**GIG HARBOR  
CITY COUNCIL MEETING**

**AUGUST 8, 1994**

**RE:** SPR 94-01 -- Request for site plan approval for a retail/office building located at 5790 Soundview Drive.

SITE PLAN

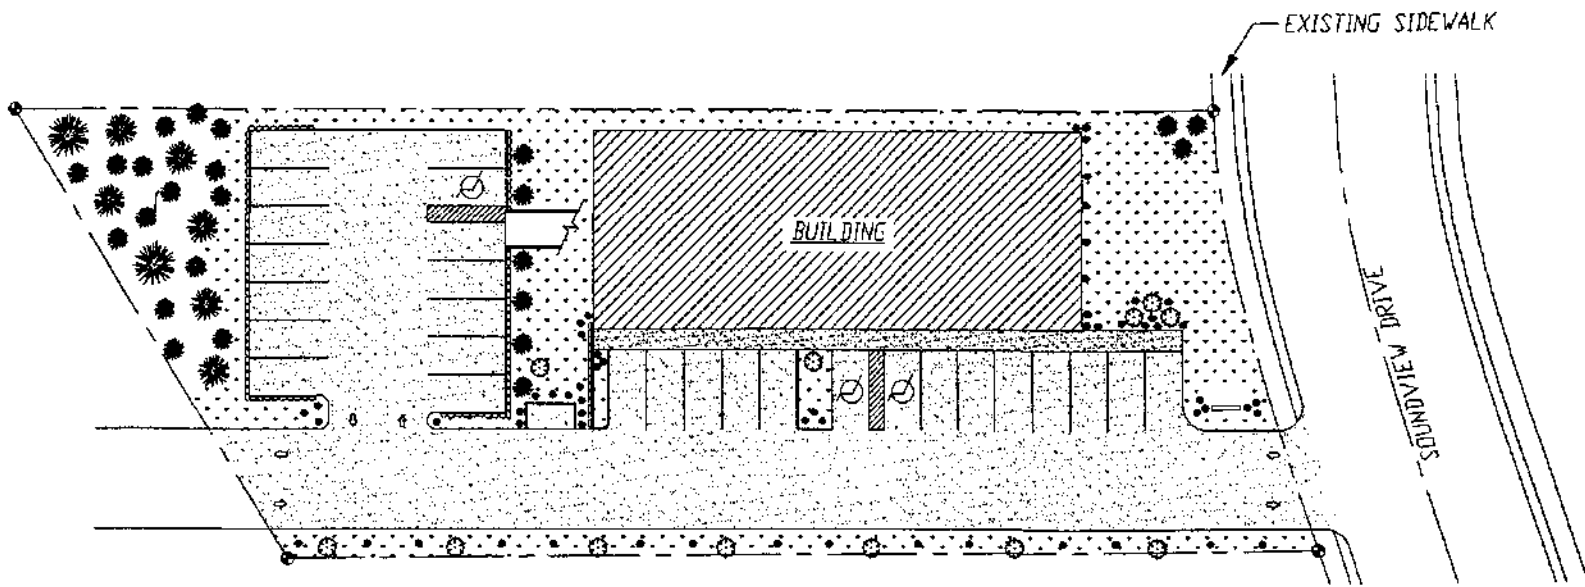
ground floor access from the parking areas. The plan includes parking in both the side and rear yards of the building and provides for a total of 28 parking spaces. Additionally, the plan indicates a driveway access to the Tacoma/Cushman right-of-way. Access to the right-of-way is assumably being retained for over-flow parking. However, there is sufficient code required parking on the site based upon the required one space per 300 square feet of office/retail floor area. The proposed building will include 8,208 square feet of floor area including 5,593 square feet on the main floor and 2615 square feet on the second floor.

In addition to significant tree loss in the rear yard, the plan shows no attempt to preserve trees in the large landscape area near Soundview Drive. A number of trees could be saved in this area with proper precautions before and during construction including (a) identification of building footprints and parking locations, (b) identifying limits of disturbance which includes a reasonable area for construction activities, and (c) the installation of a protective barricade or fence to protect vegetation during the entire construction phase.

1. A storm water drainage plan must be submitted to the Public Works Department prior to building permit issuance.
2. All significant trees within the proposed buffer and perimeter landscape areas (front, rear, and sides) shall be retained. **This will require eliminating the proposed driveway access to the Tacoma/Cushman right-of-way.** It will also require preliminary identification of the building and parking pavement edge and installation of a protective barricade before major excavation begins. The barricade should be visually and functionally significant (e.g., a fence made of plywood or construction safety fencing attached to steel T-posts or heavy lumber). The barricade shall be retained and maintained in good condition during the entire construction phase, including major excavation and clearing, and shall not be removed until the parking area has been paved or until approved by the Planning Staff.

8. The final site and landscape plan shall indicate a location for waste recycling bins.

9. All trees, shrubs and/or power poles located within the right-of-way which interfere with safe sight distances shall be removed. The Public Works Department shall review and approve final site and landscape plans to assure adequate sight distance.

LANDSCAPE SITE PLAN

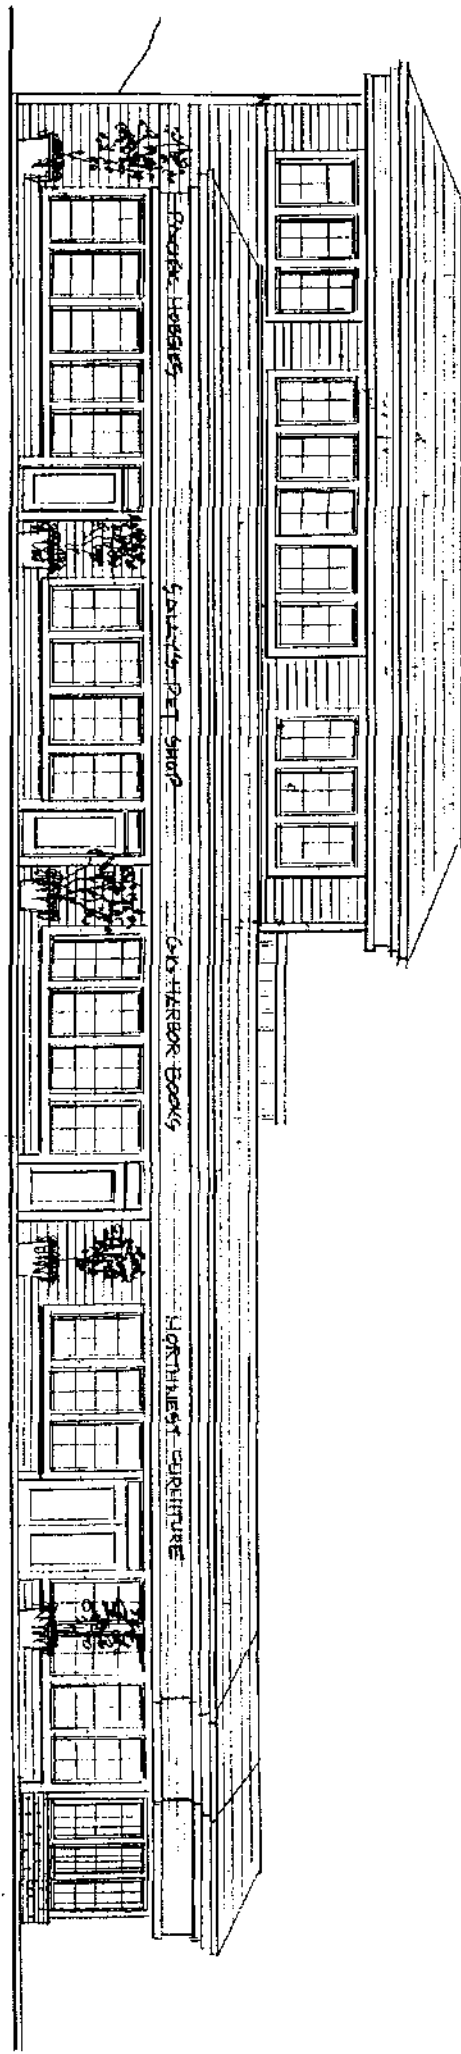
**WHEREAS**; the City Council, during its regularly scheduled meeting of August 9, 1993, has considered the Hearing Examiner's recommendation and has determined that his recommendation relies upon (a) approval of an alternative landscape plan as defined in GHMC 17.78.100 which allows an alternative landscape plan if the landscape plan is superior to what would be achieved through a strict application of the code's landscaping requirements, or (b) a variance from the zoning code requirements to provide a twenty five foot wide buffer in the rear and to retain significant vegetation within perimeter and buffer areas (GHMC sections 17.78.090 and 17.78.050 respectively); and,

**WHEREAS**, the City Council has determined that the proposed landscape plan does not result in a superior landscape plan that what would be achieved through a strict application of the code but in fact results in less vegetative areas and in a significant loss of significant on-site vegetation that would otherwise be achieved through a strict application of the code; and

A final landscape plan should be submitted which indicates which indicates significant vegetation to be retained on both the front and rear side of the building (b) indicates specific plant species in accordance with zoning code landscaping requirements, and (c) indicates a sprinkling plan.

7. Prior to permit issuance, a final landscape plan shall be reviewed and approved by the Planning Staff. The plan shall indicate (a) significant vegetation to be retained on both the front, rear, and side of the building, (b) specific plant species in accordance with zoning code landscaping requirements, and (c) a sprinkling plan.

10 The landscape plan shall meet all regular provisions of the code
